RE: Request for Inclusion
City of Hollywood, Florida
Bypass Bar Screen – WW0604G

The following is the response to your request for information dated May 7, 2025, regarding the Emergency Bar Screen By-Pass project.

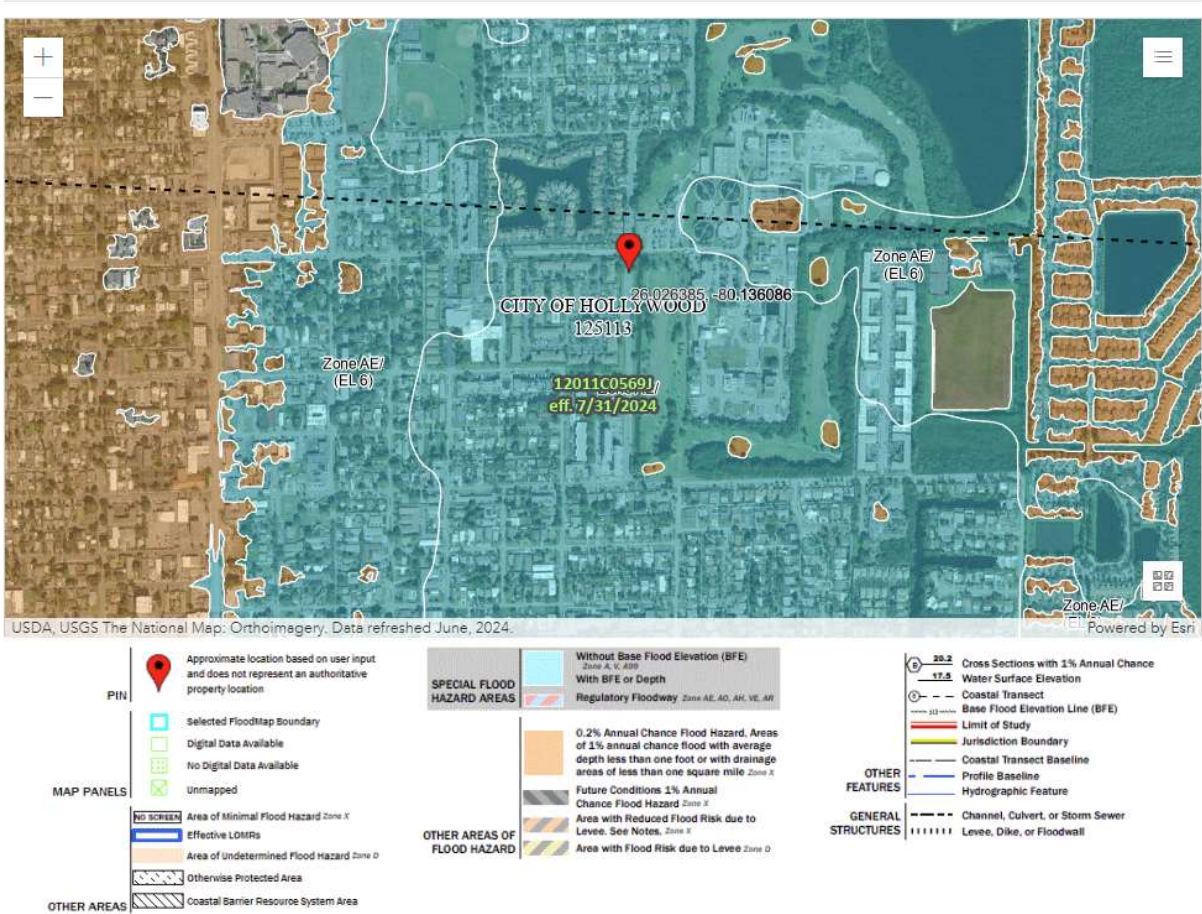
9. Discussion of the 100-year flood plain in relation to this project and provide supporting documentation, e.g. FEMA maps.

The project is located within Zone AE. The FEMA map is provided below. All electrical equipment will be installed above the flooding elevation.
